KIRSTEN REITE
ARCHITECTURE

PROJECT: Haida Gwaii Pharmacy Renovation Project

KRA project no.: 2024-025

ADDENDUM NO.6

A2.100

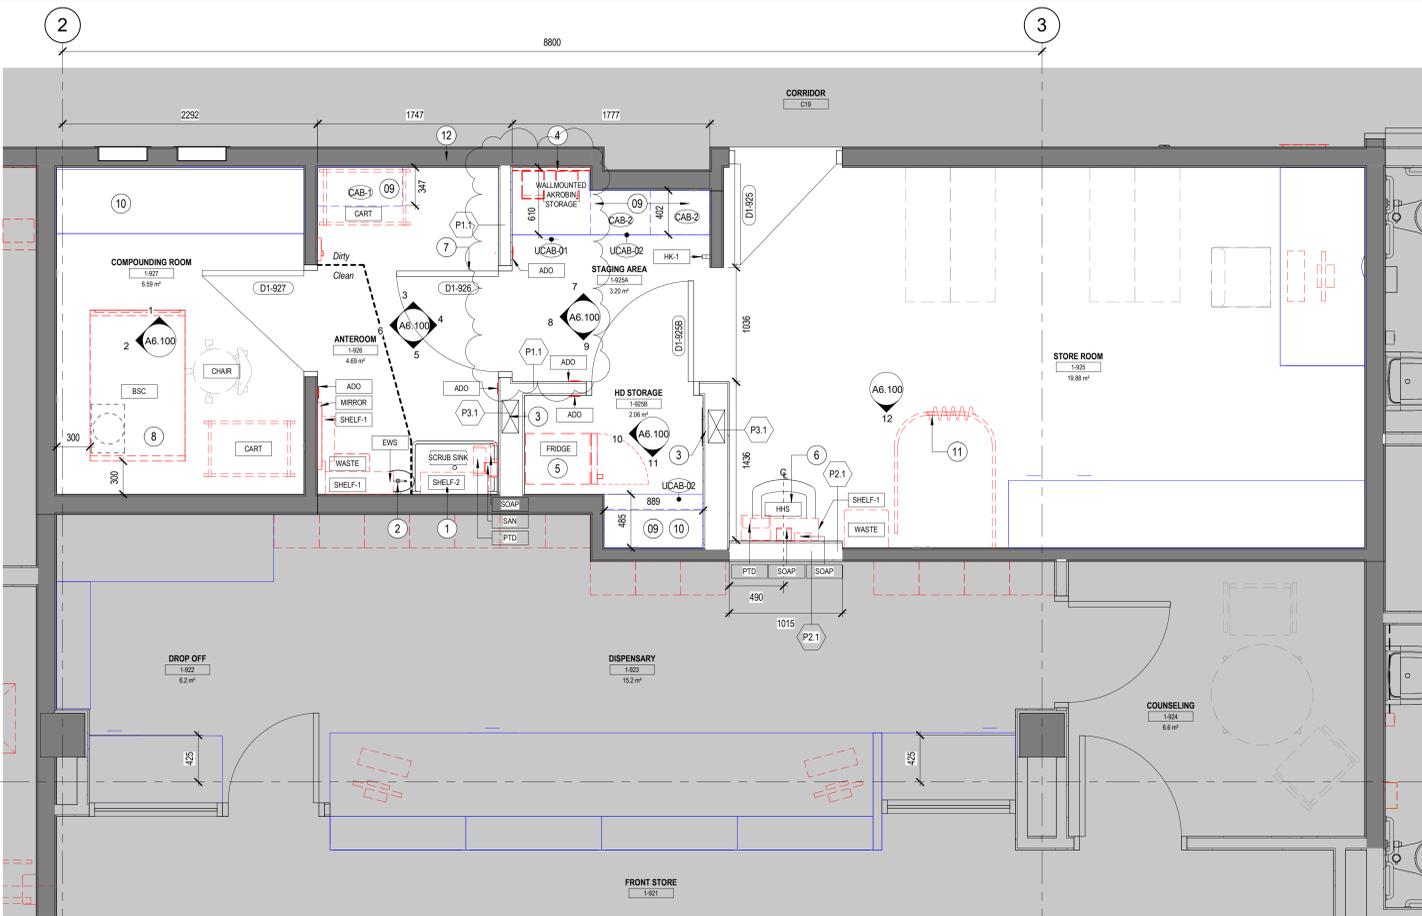
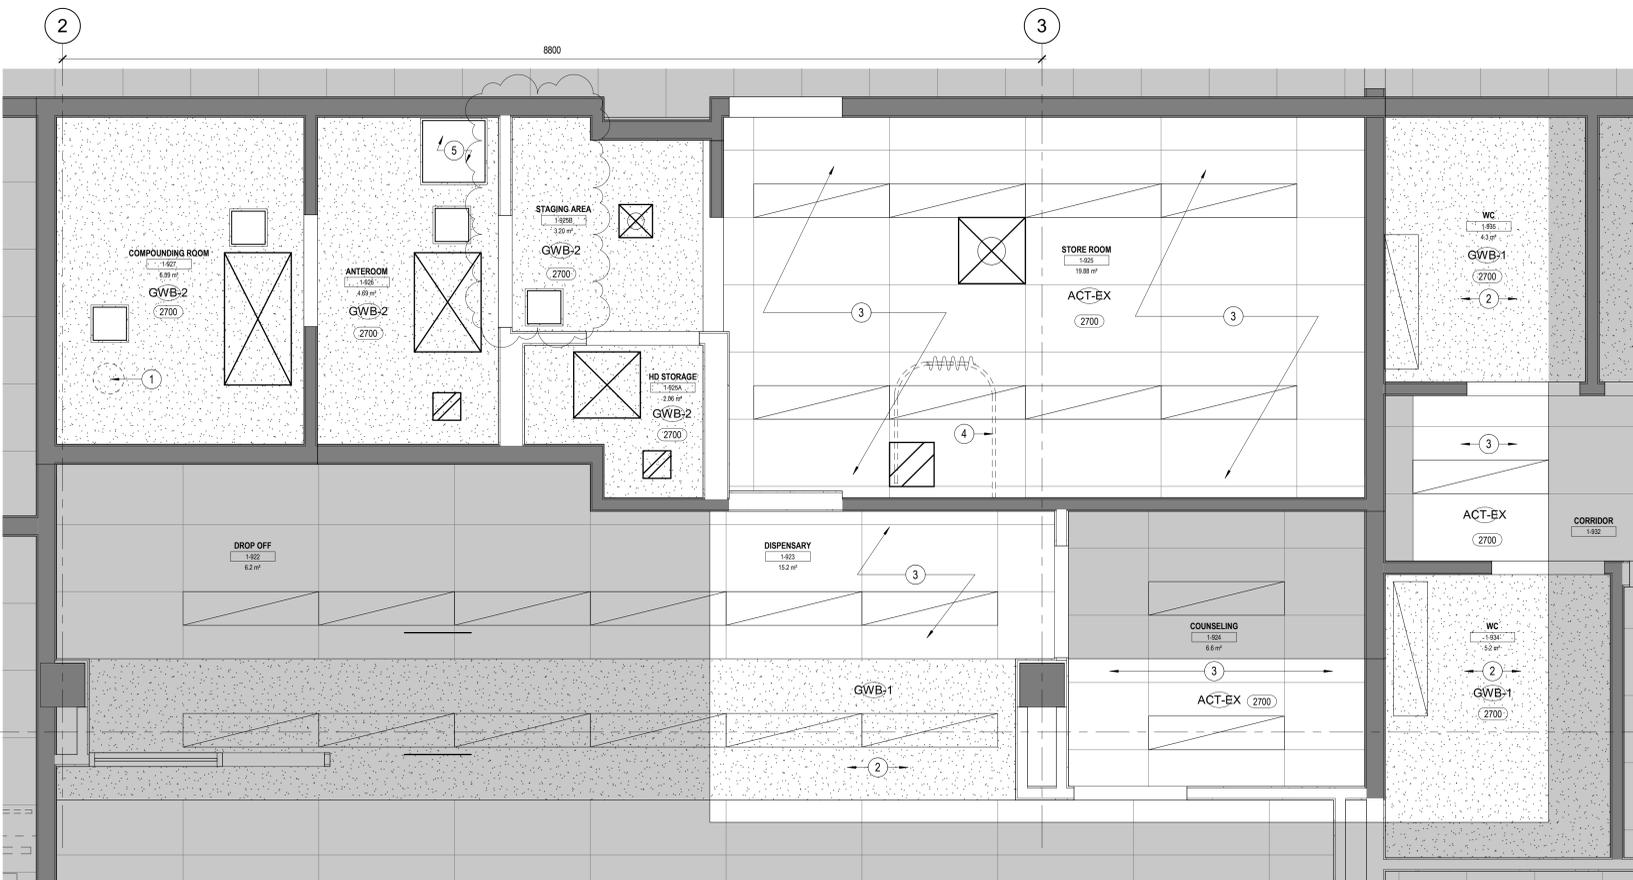
- .1 Sheet A2.100 -- Level 01 – Proposed Floor Plan and Ceiling Plan – Refer to attached revised drawing sheet.
a) **REVISE** wall type at north portion of wall assembly between Staging Area and Anteroom.
b) **REVISE** extent of GWB ceiling & bulkhead to suit revised wall type.
- .2 Sheet A6.100 – Interior Elevations, Millwork Schedule & Details – Refer to attached revised drawing sheet.
a) **REVISE** width of lower cabinet 'UCAB-01'.
b) **REVISE** counter edges to form 90-degree corners.
